# NATIONAL ENRICHMENT FACILITY

## SAFETY ANALYSIS REPORT

Revision 16c

Figure 2.1-1 LES Corporate, Design and Construction Organization

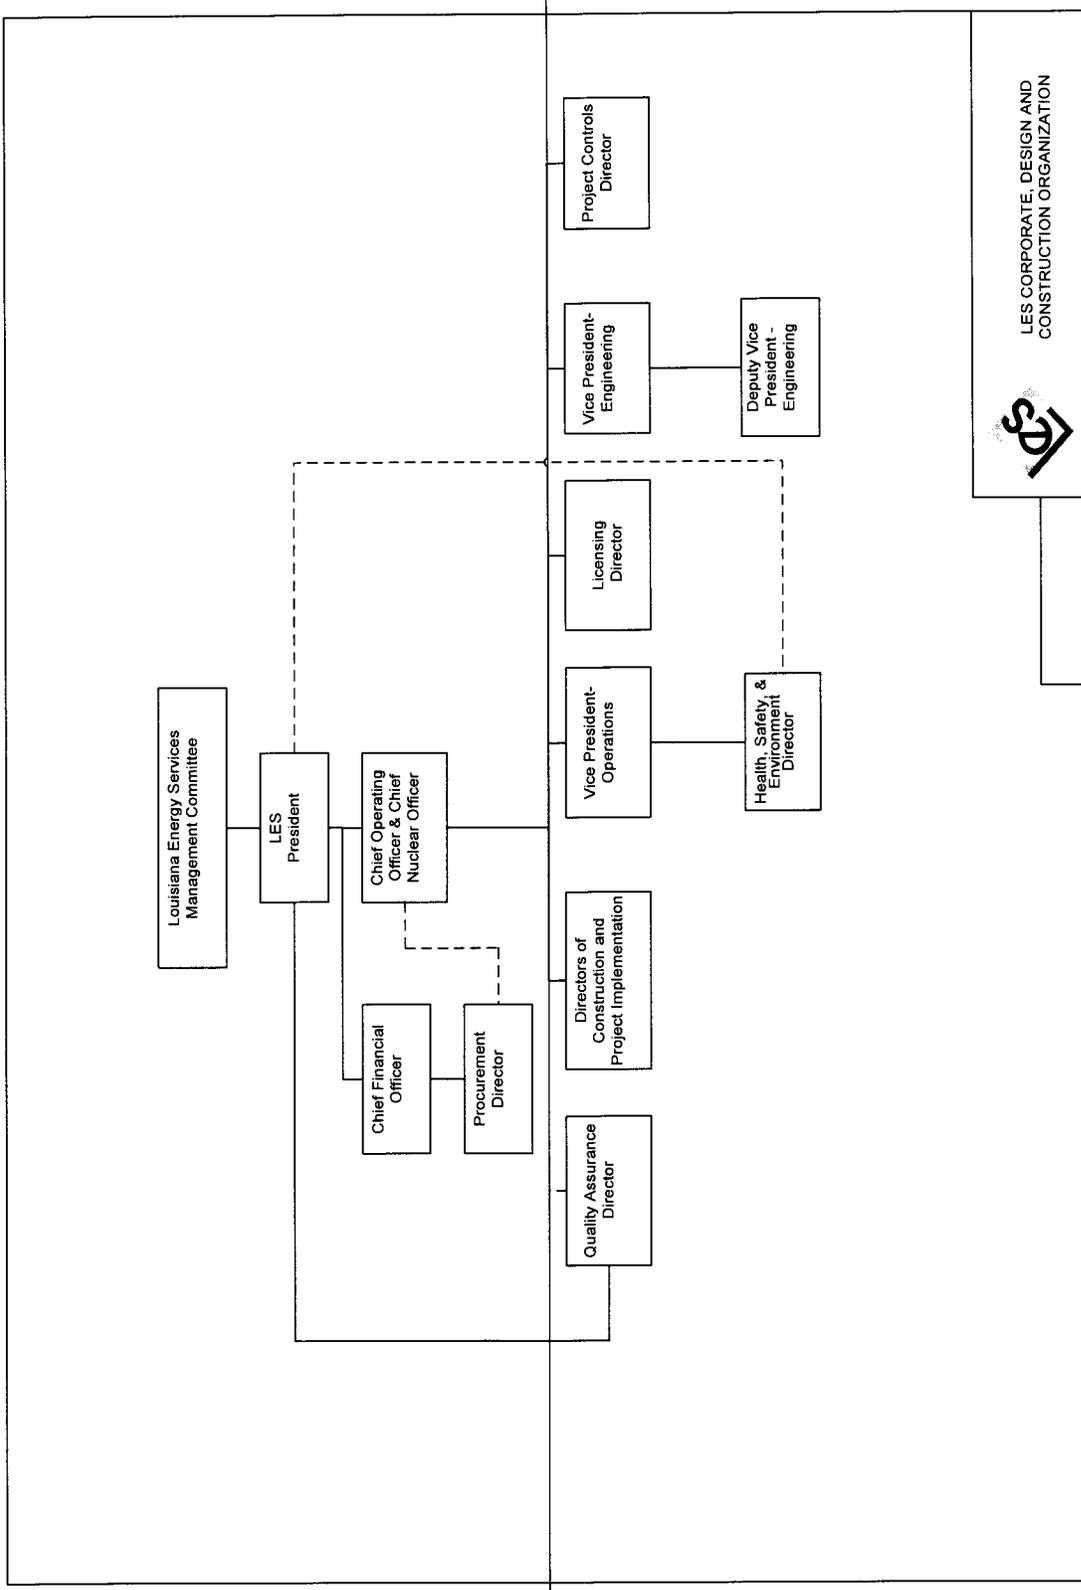
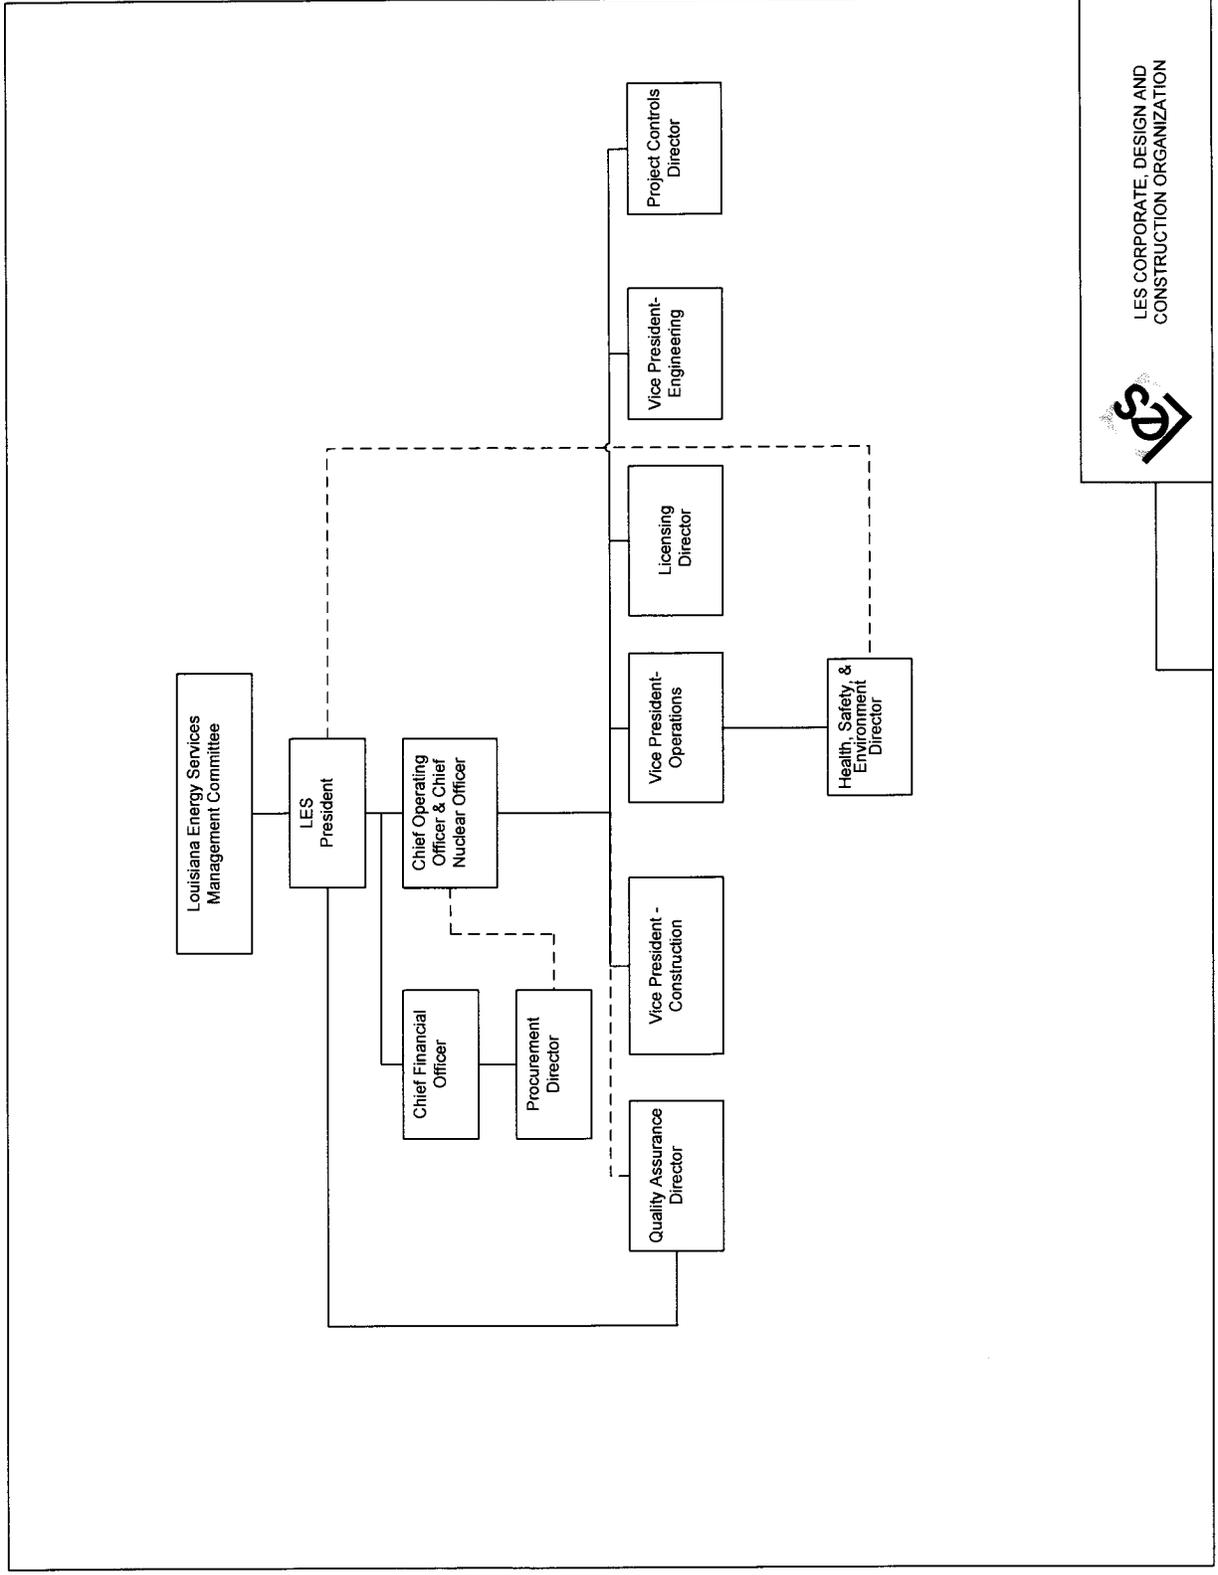
The President receives policy direction from the LES Management Committee. Reporting to the President is the Chief Operating Officer & Chief Nuclear Officer. The Vice President - Engineering, Quality Assurance (QA) Director, Vice President - Operations, Project Controls Director, ~~Director of Construction & Project Implementation~~ Vice President - Construction and Licensing Director all report to the Chief Operating Officer & Chief Nuclear Officer. The Quality Assurance Director reports to the Chief Operating Officer & Chief Nuclear Officer for functional day to day activities and has a direct reporting relationship to the President for all quality related activities. The Health, Safety & Environment Director reports to the Vice President - Operations, but has a direct reporting relationship to the President for all matters concerning safety during design and construction. Figure 2.1-1, LES Corporate, Design and Construction Organization shows the authority and lines of communication.

During the construction phase, preparation of construction documents and construction itself are contracted to qualified contractors. The ~~Director of Construction & Project Implementation~~ Vice President of Construction is responsible for managing, construction and construction turnover testing activities. The Vice President of Engineering has overall design responsibility and the ~~Deputy Vice President of Engineering~~ is the responsible design authority during construction. The Procurement Director is responsible for the procurement. Contractor QA Programs will be reviewed by LES QA and must be approved before work can start.

The ~~Director of Construction & Project Implementation~~ Vice President of Construction is responsible for managing the work and contracts. The Project Controls Director is responsible for scheduling and project financial controls and reports directly to the Chief Operating Officer and Chief Nuclear Officer. The lines of communication of key management positions within the engineering and construction organization are shown in Figure 2.1-1.
